Item Name: Crosstube Turning Detail

<b>DART AEROSPACE LTD</b>		<b>Work Order:</b>	93995
<b>Description:</b> Crosstube Assembly (205/212/412 High Fwd)		<b>Part Number:</b>	D212-664-141
<b>Inspection Dwg:</b> D212-664-141 Rev: D		<b>Page 1 of 2</b>

DESIGN	PH	<b>DART AEROSPACE LTD</b> HAWKESBURY, ONTARIO, CANADA	
DRAWN	RF		
CHECKED	97	DRAWING NO.	REV. D
MFG. APPR.	11	D212-664-141	SHEET 2 OF 4
APPROVED	11	TITLE	SCALE
DE APPR.	11	XTUBE ASS'Y (205/212/412 HI FWD)	NTS
DATE	09.09.30	COPYRIGHT © 2000 BY DART AEROSPACE LTD THIS DOCUMENT IS PRIVATE AND CONFIDENTIAL AND IS SUPPLIED ON THE EXPRESS CONDITION THAT IT IS NOT TO BE USED FOR ANY PURPOSE OR COPIED OR COMMUNICATED TO ANY OTHER PERSON WITHOUT WRITTEN PERMISSION FROM DART AEROSPACE LTD.

DRAWING NO. D212-664-141	TITLE XTUBE ASSY (205/212/412 HI FWD)	REV. D	DART AEROSPACE LTD ENGINEERING ORDER		D.E.O. NO. D212-664-141-D-1	SHEET NO. SHEET 1 OF 2	SCALE NTS
DRAWN	CHECKED	MFG. APPR.	APPROVED	DE APPR.			
DATE 11.04.07	DATE 11.04.11	DATE 11.04.12	DATE 11/04/12	DATE 11.04.12

**D212-664-141/-141B  
ASSEMBLY DETAIL**

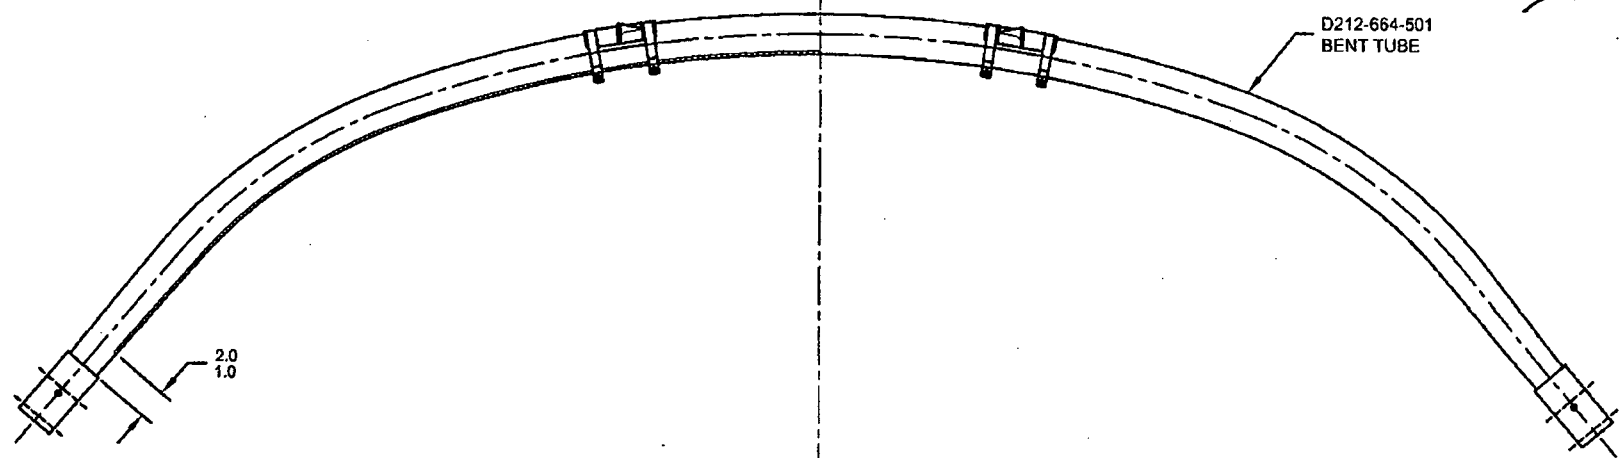
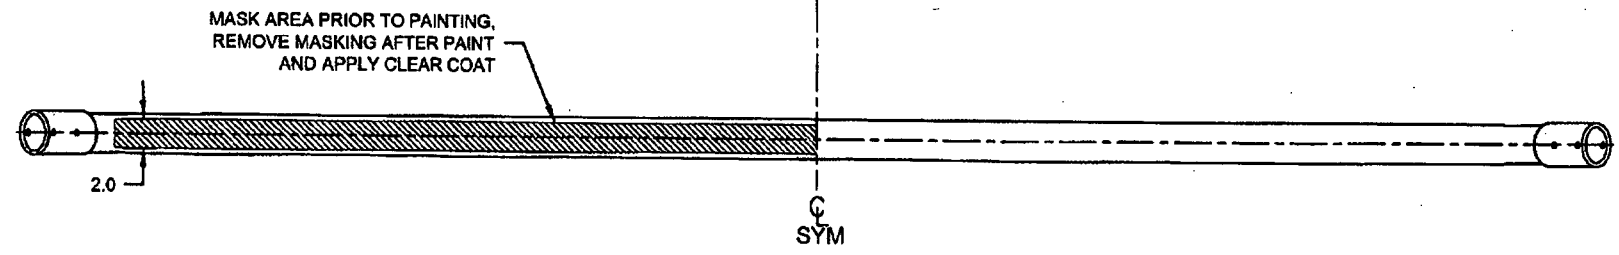
**PURPOSE:**

ADD AN INSPECTION WINDOW TO UNDERSIDE OF CROSSTUBE.

**CHANGE:**

NOTES 2 OF SHEET 1 IS AMENDED AS FOLLOWS:

**IS:**

- 2) FINISH: CHEMICAL CONVERSION COAT PER DART QSI 005 4.1  
PRIME INSIDE AND OUTSIDE PER DART QSI 005 4.2  
MASK UNDERSIDE OF CROSSTUBE AS SHOWN (HATCHED AREA) AND  
PAINT OUTSIDE PER DART QSI 005 4.2  
REMOVE MASKING AND APPLY CLEAR COAT

**WAS:**

- 2) FINISH: CHEMICAL CONVERSION COAT PER DART QSI 005 4.1  
PRIME INSIDE AND OUTSIDE PER DART QSI 005 4.2  
PAINT OUTSIDE PER DART QSI 005 4.2
